ADDENDUM TO THE CONTRACT

Gastineau Elementary School Renovation

Contract No. E11-137

ADDENDUM NO.: FOUR

M0.1

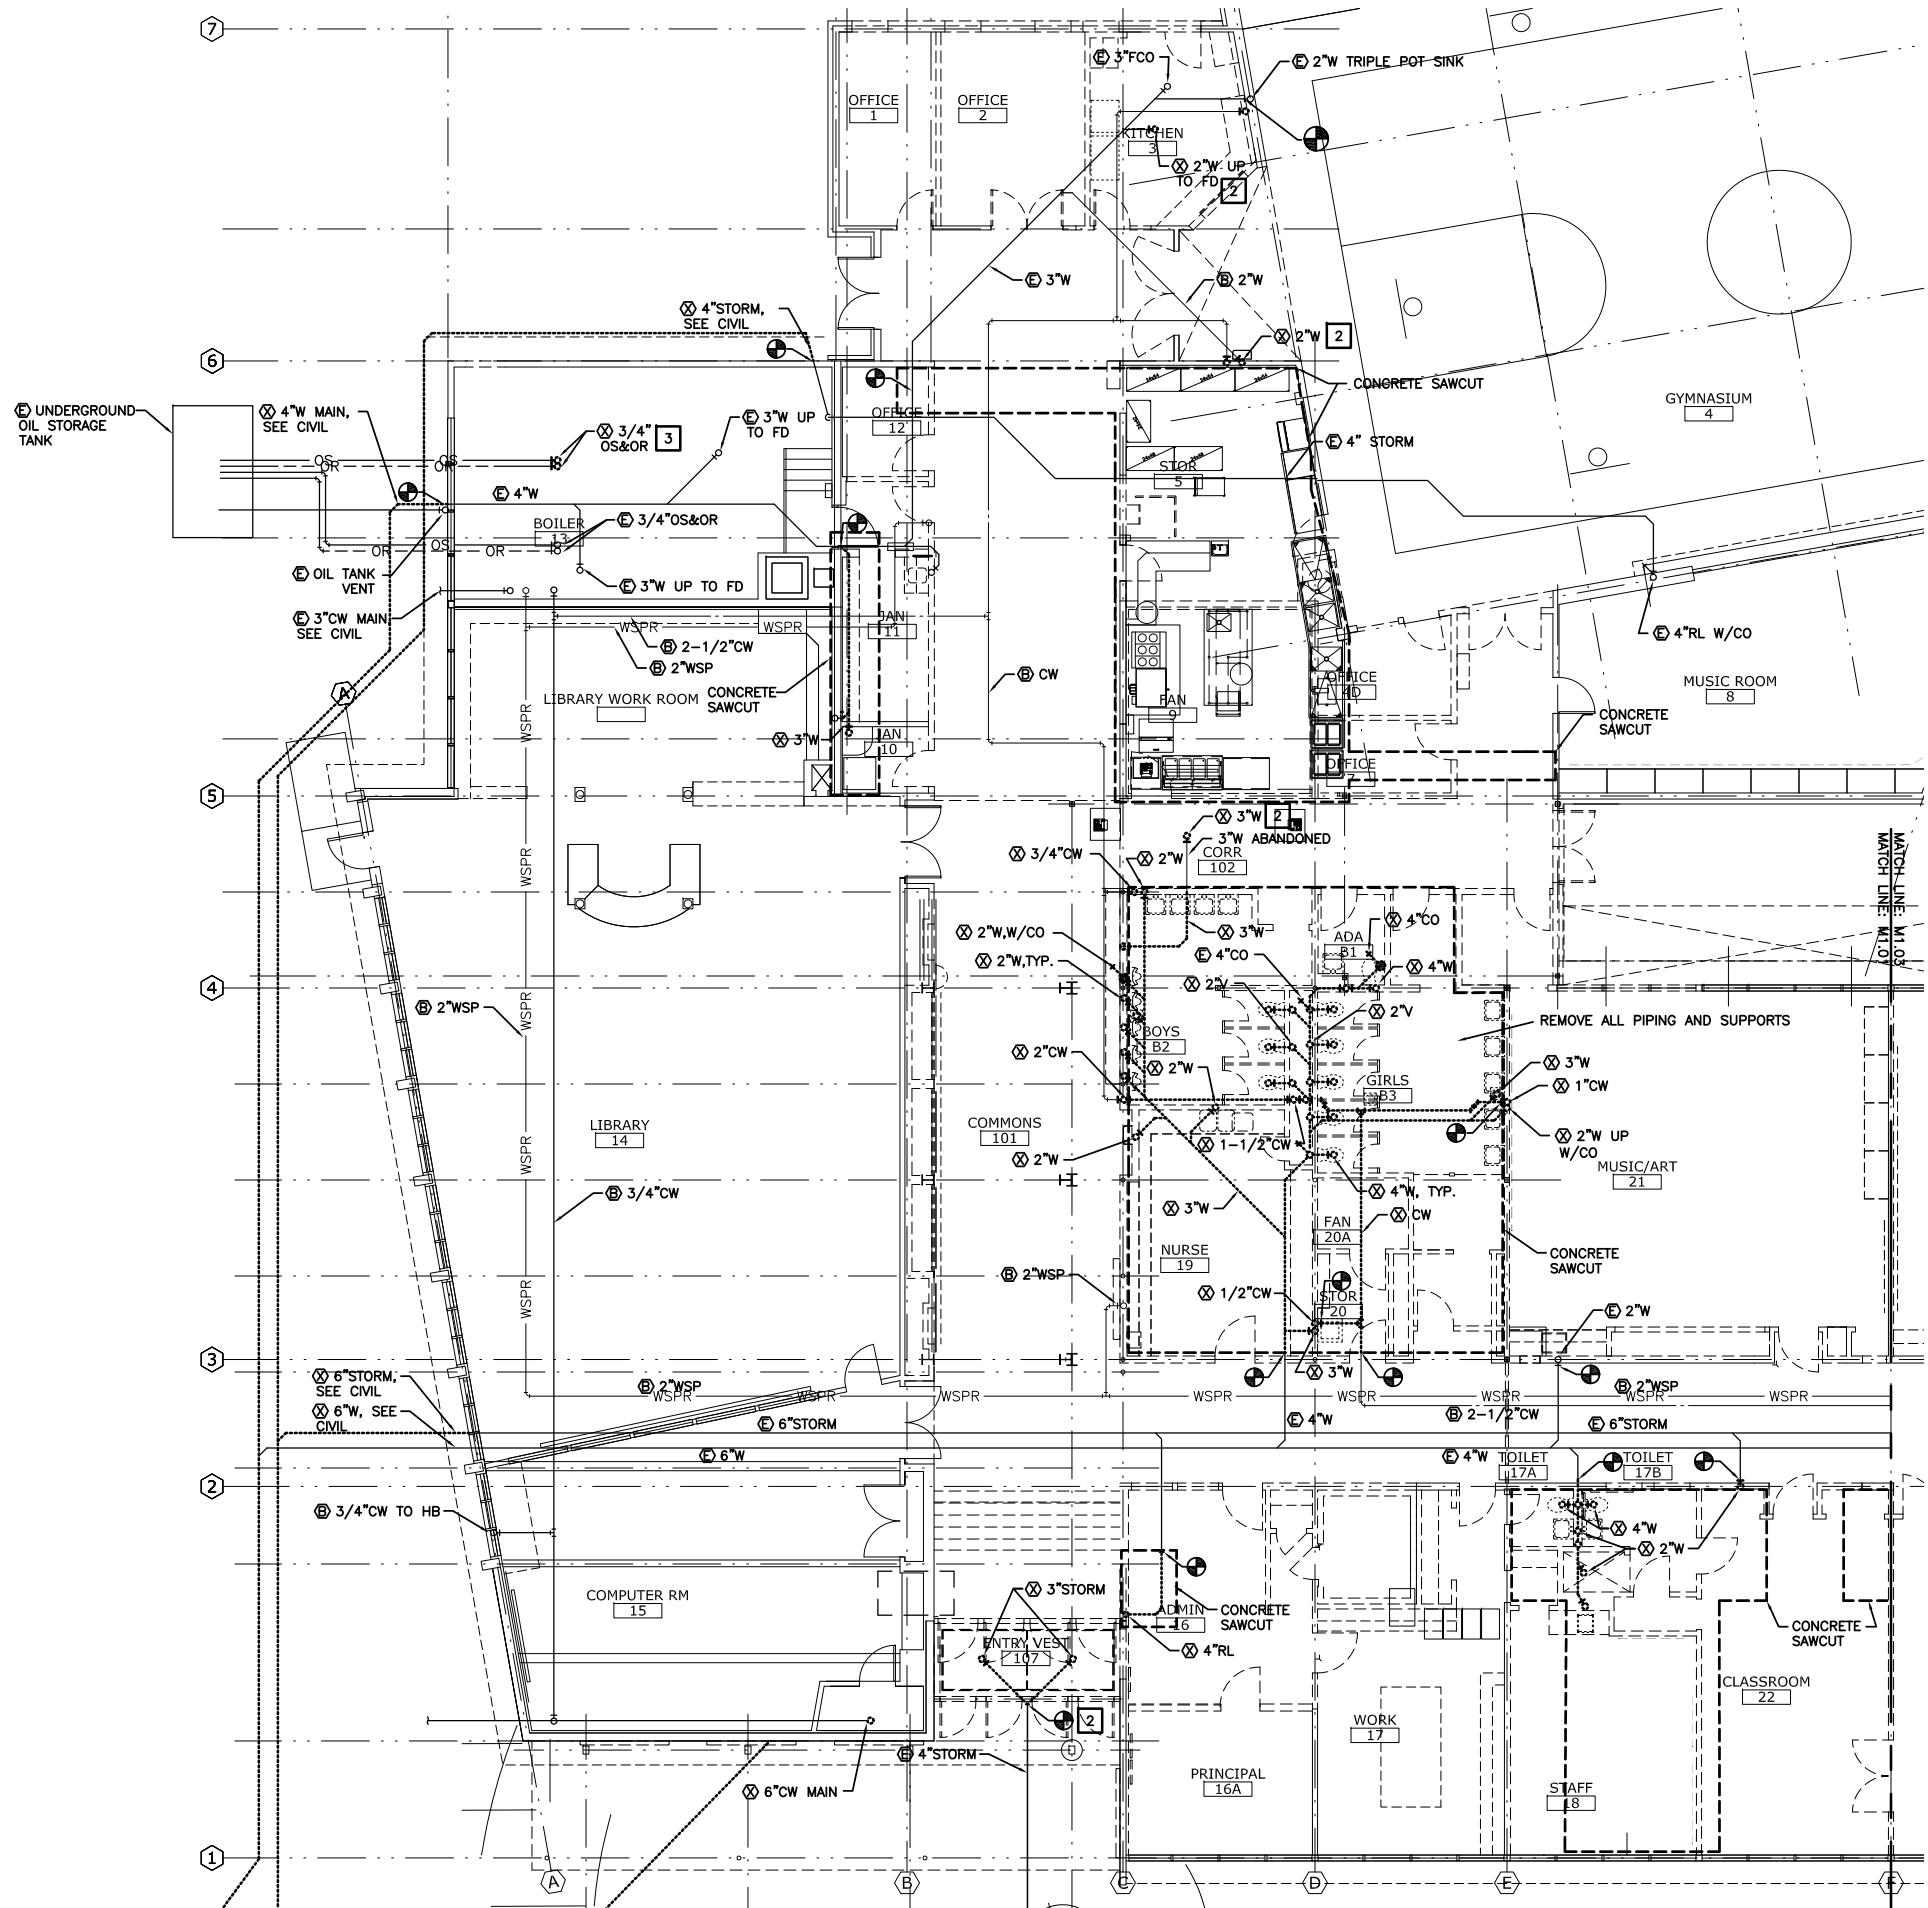
***Replace** sheet in its entirety with M0.1 included with addendum. This sheet replaced to correct sheet schedule.*

SHEET TITLE:
DEMOLITION PLAN DOMESTIC PIPING UNDERGROUND AREA A&B

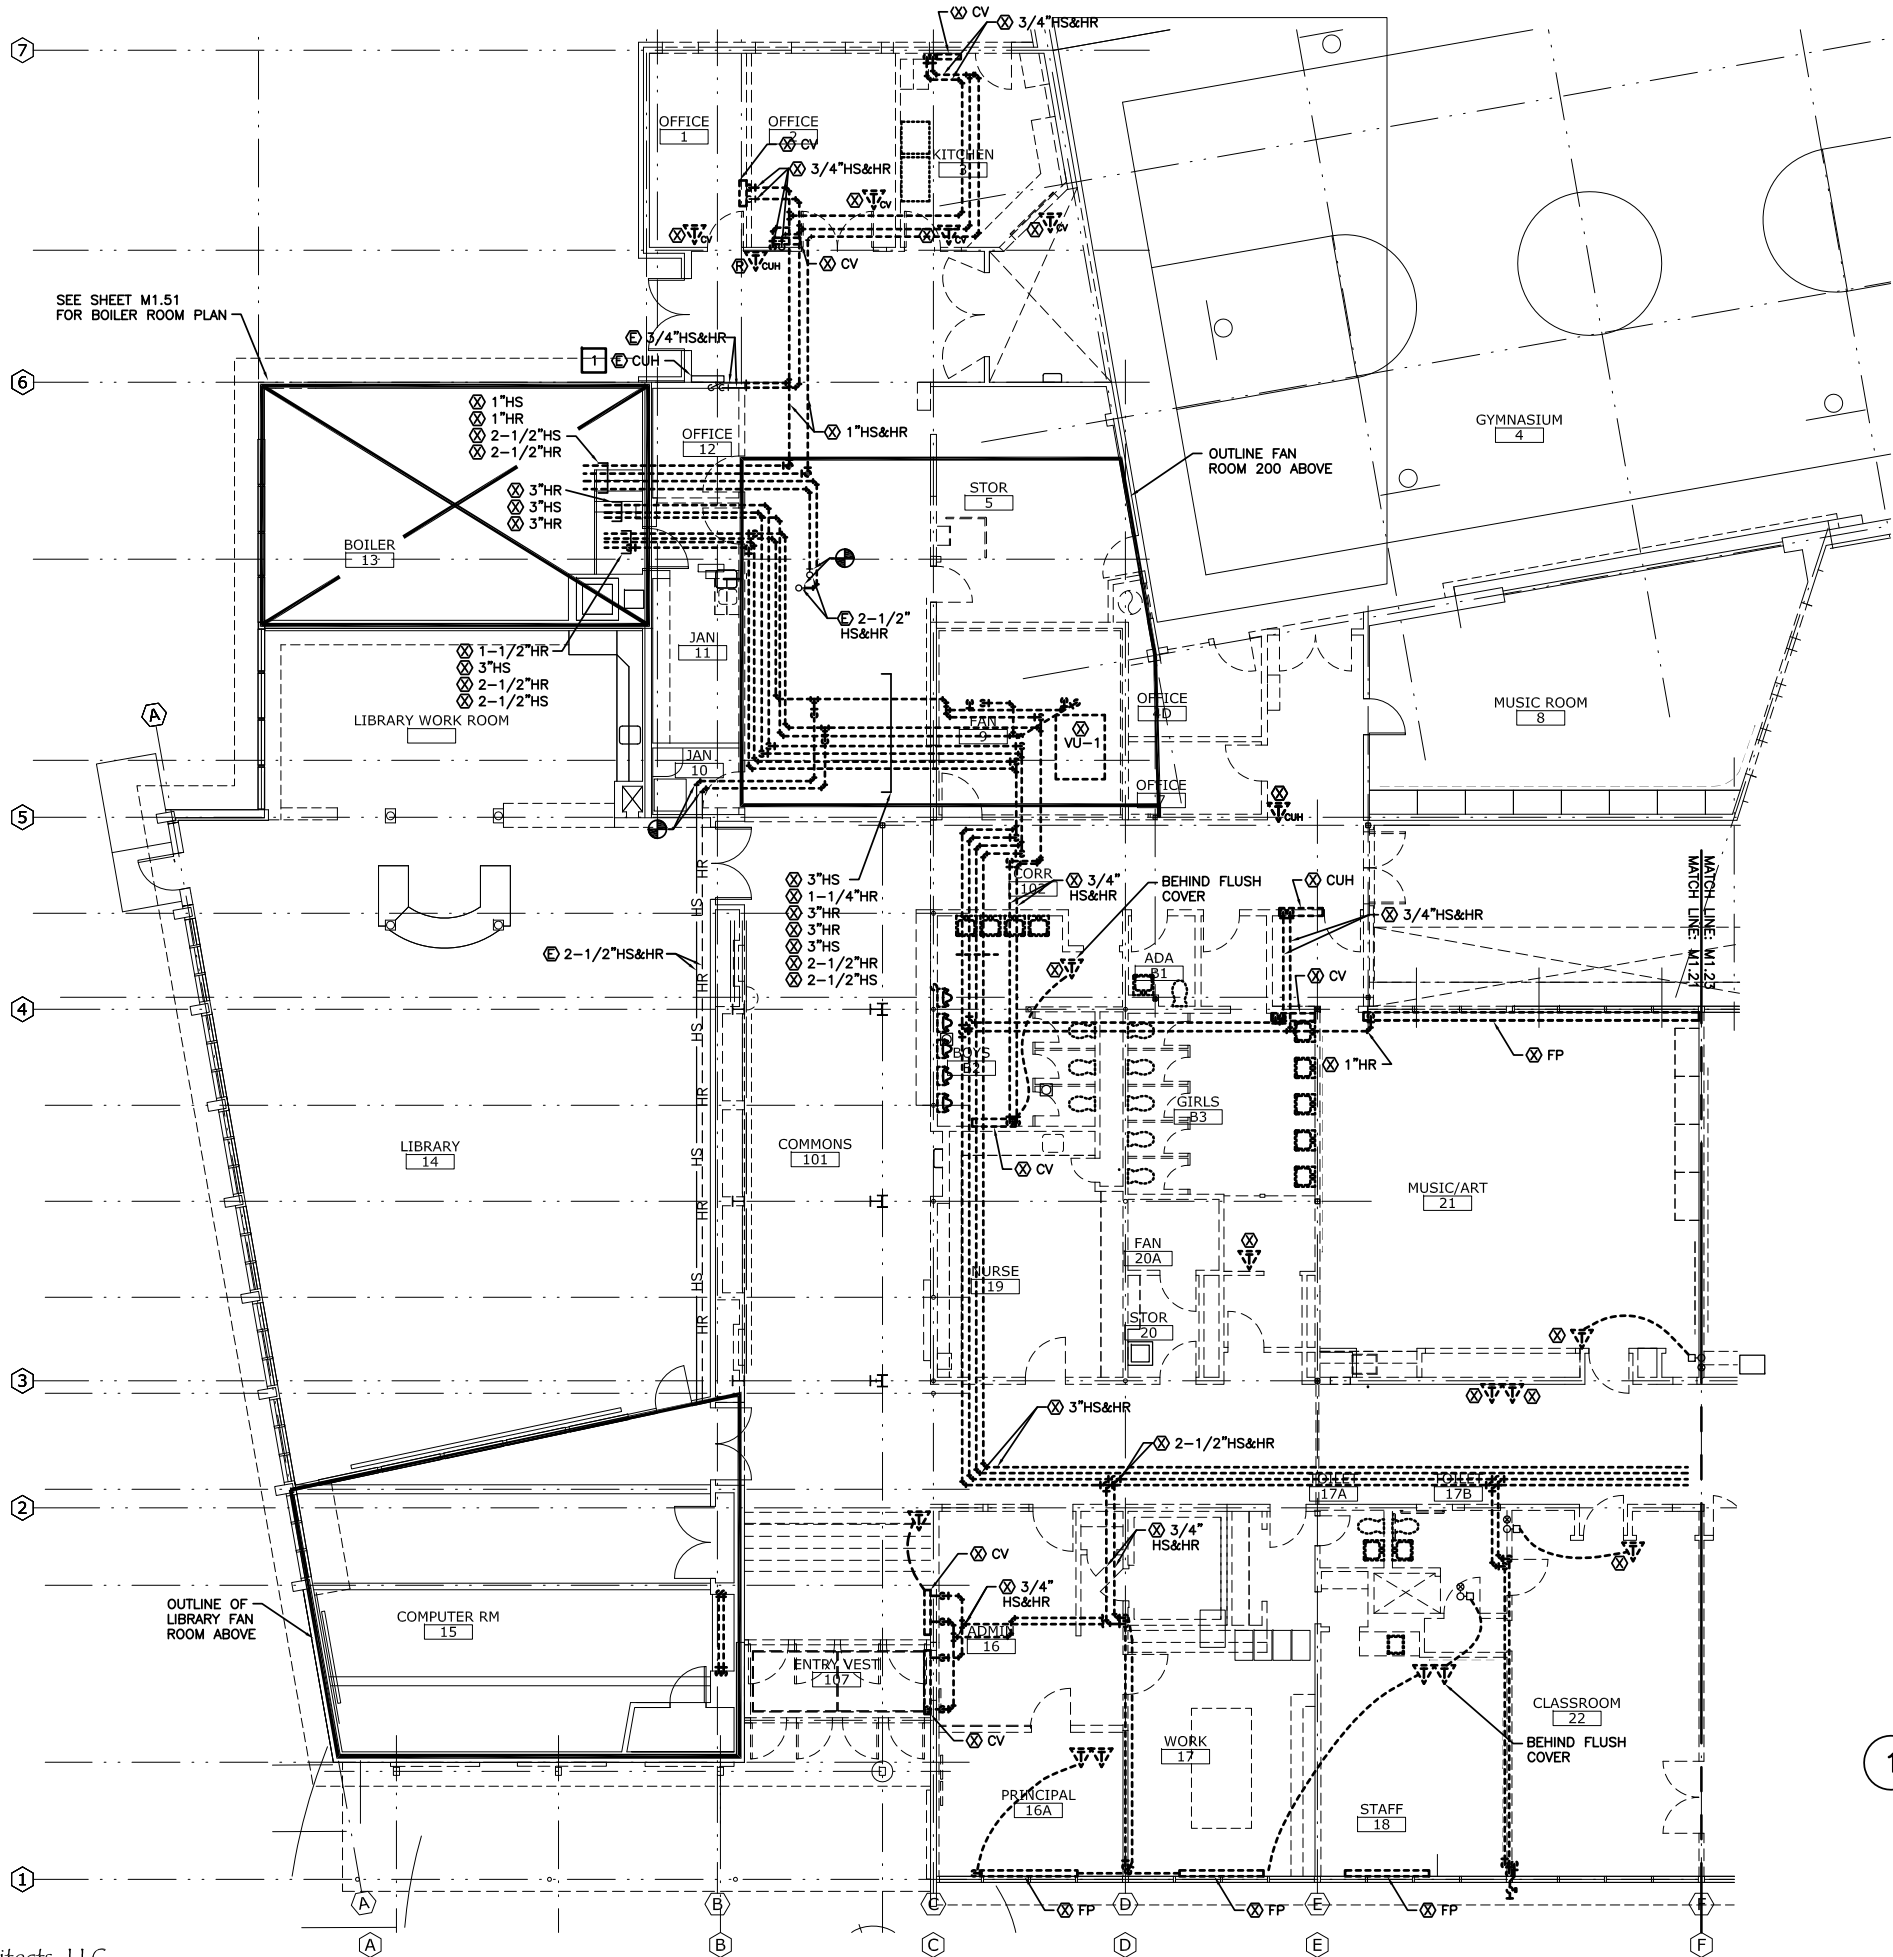
Replace sheet in its entirety with M1.01 included with addendum. This sheet replaced to correct base plan.

SHEET TITLE:
DEMOLITION PLAN HEATING PIPING AREA A&B

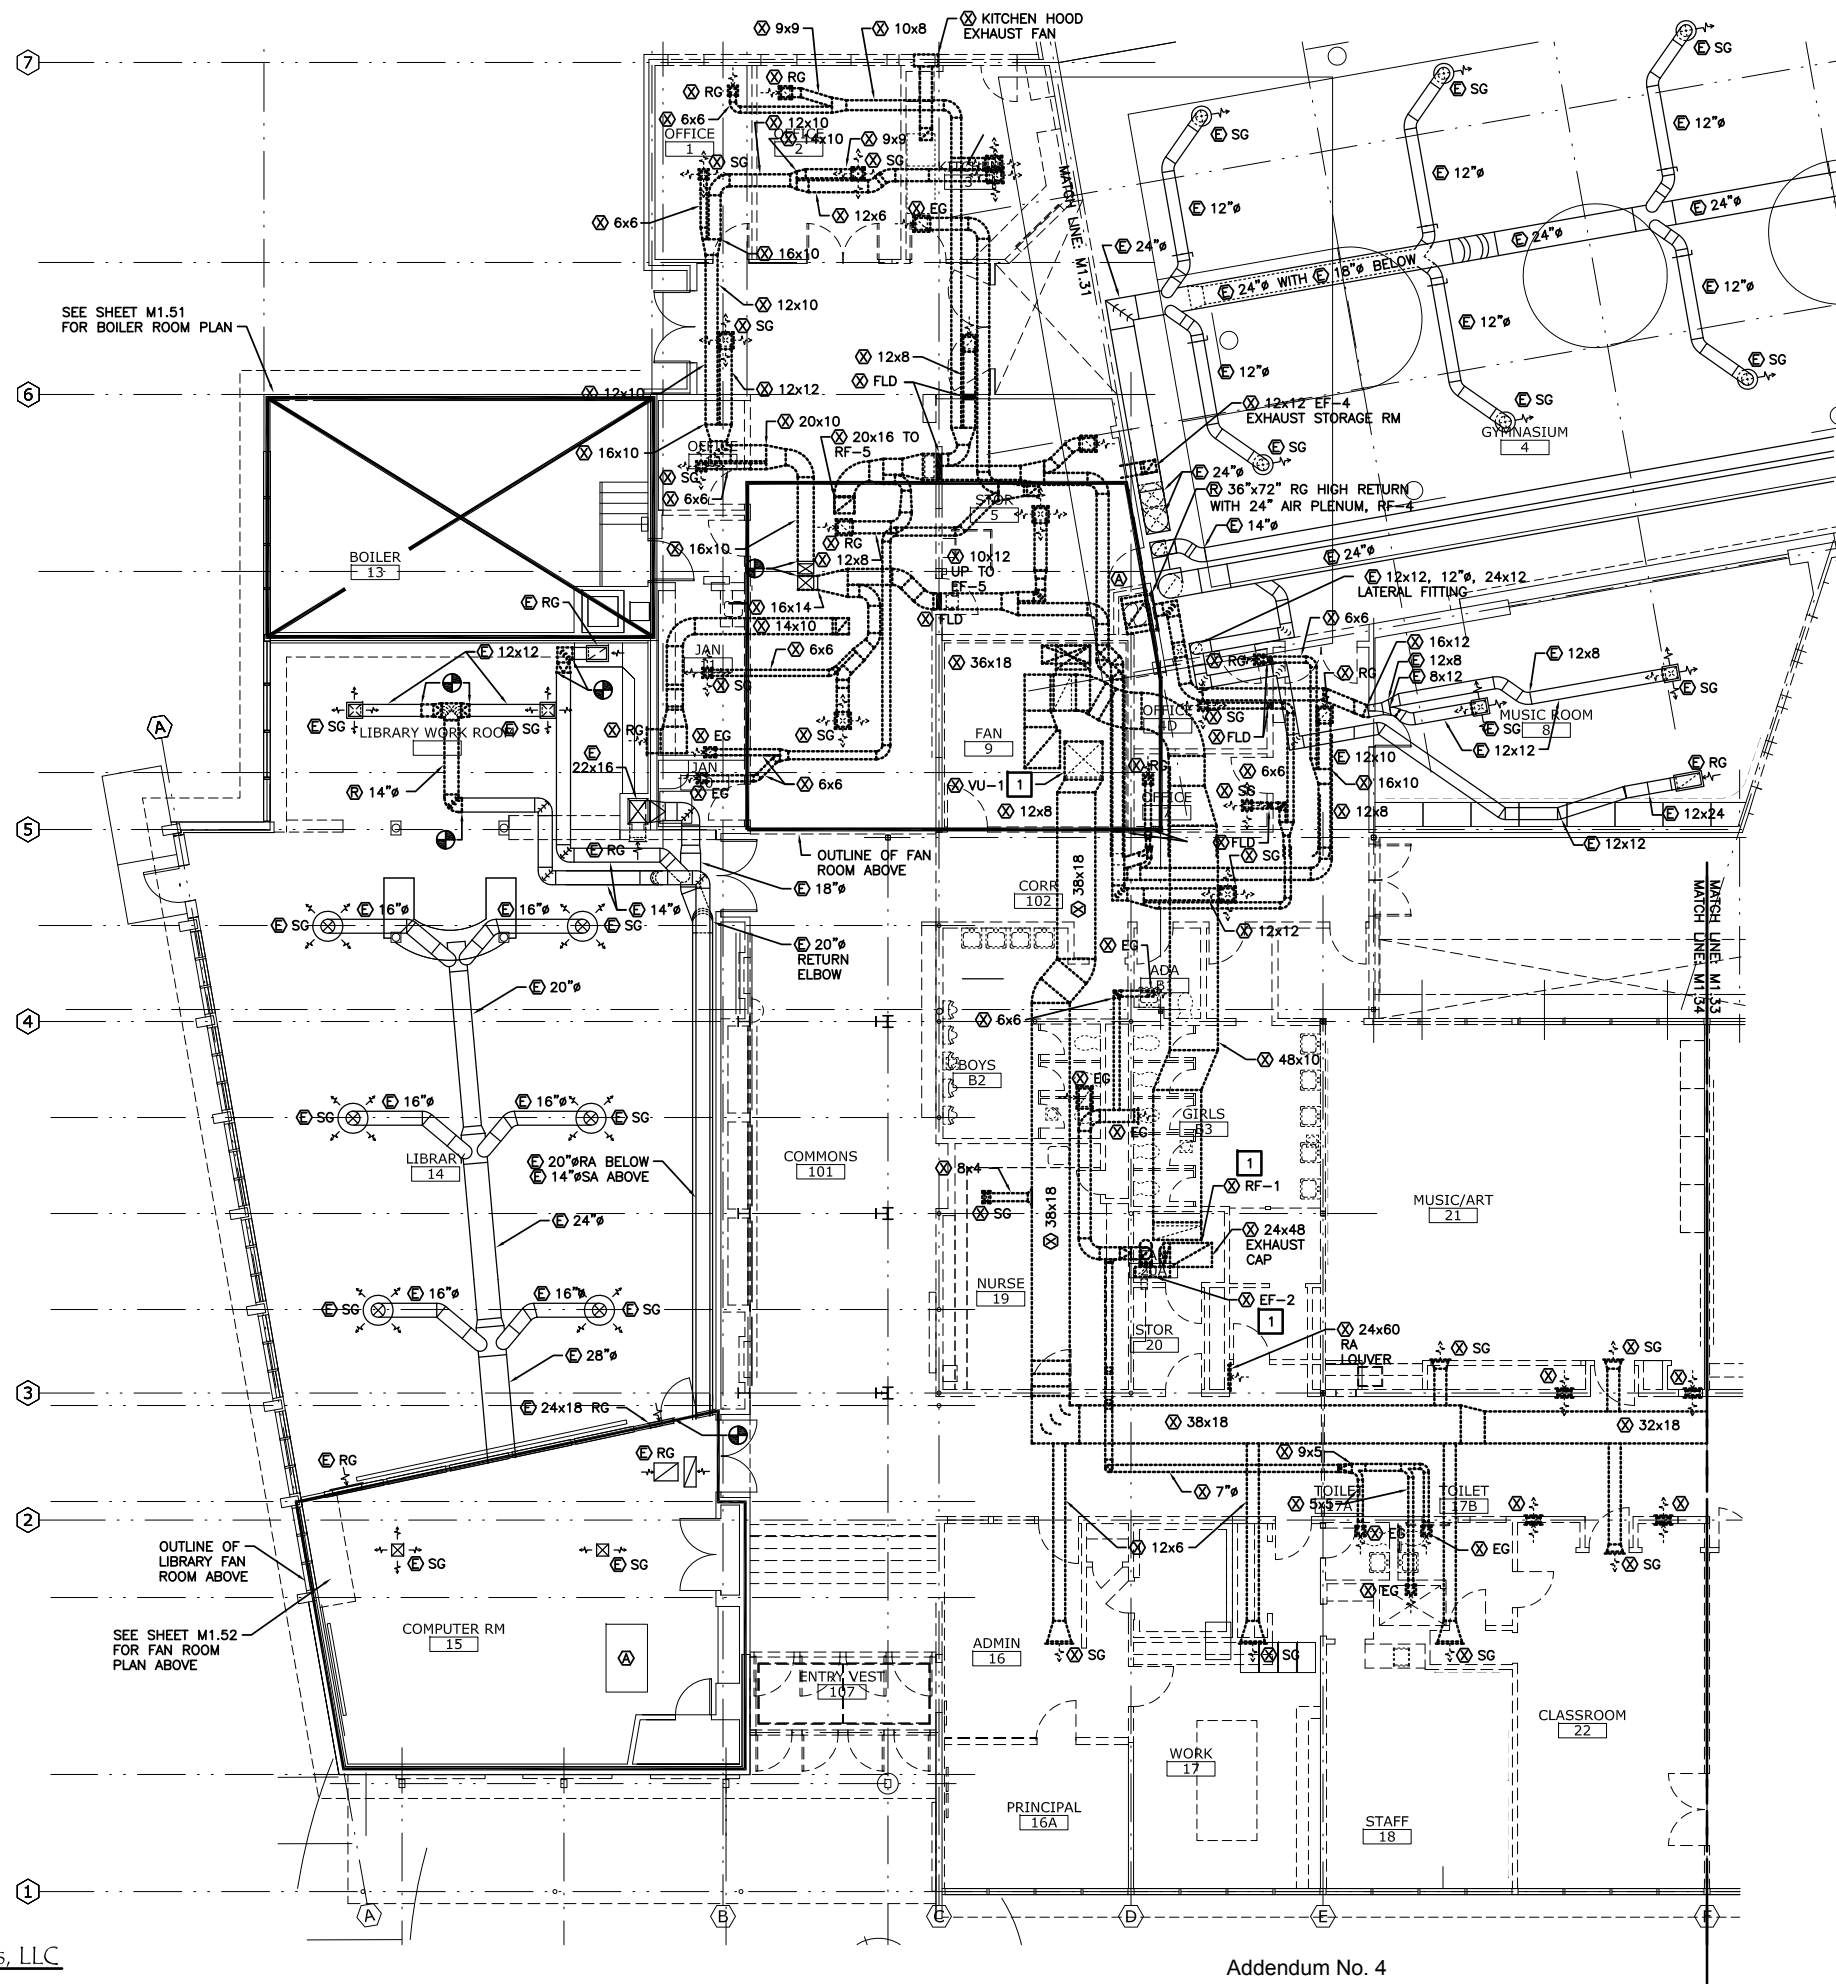
Replace sheet in its entirety with M1.21 included with addendum. This sheet replaced to correct base plan.
